| <b>ASUS</b>                 |  | <b>Title : E30 TOUCH PAD</b> |            |
| Size<br>A                   | Project Name<br><b>UX30 TOUCH PAD BD</b> |                              | Rev<br>2.0 |

UX30 TOUCH PAD BD R1.1 Change List

UX30 TOUCH PAD BD R2.0 Change List

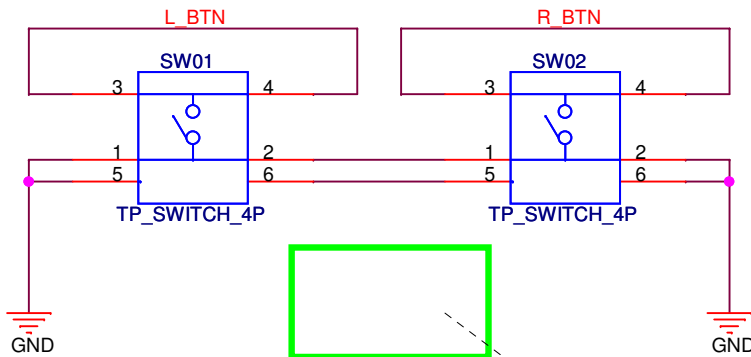
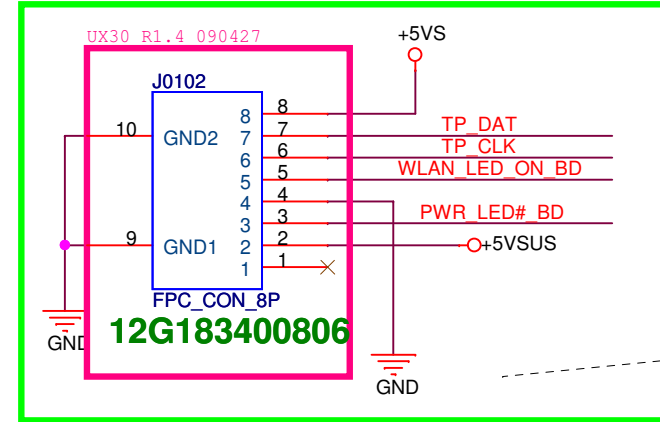
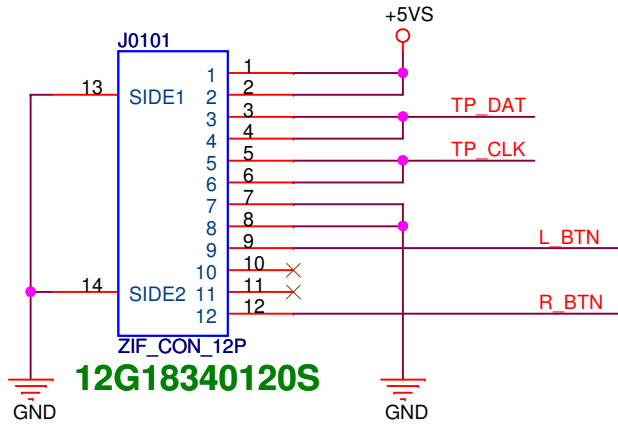
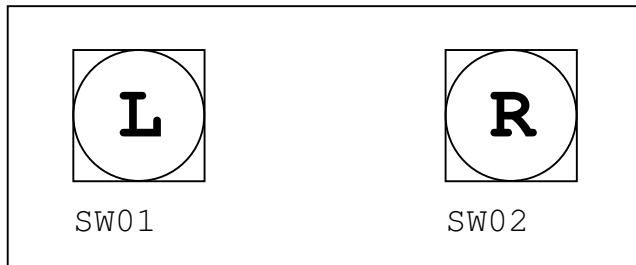
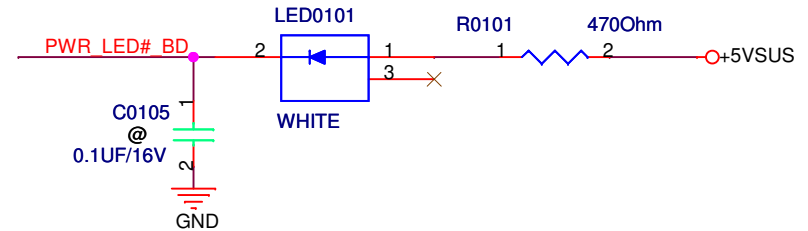
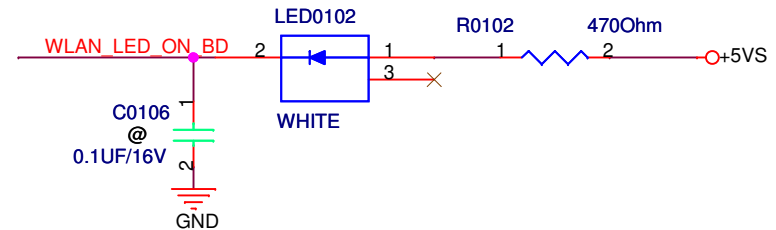
- 1. Change J0102 from 6 pin to 8 pin and change pin define for PM spec change
- 2. Add LED0101 and R0101 for PM spec change
- 3. Add LED0102 and R0102 for PM spec change

- 1. Delete C0103 and C0104
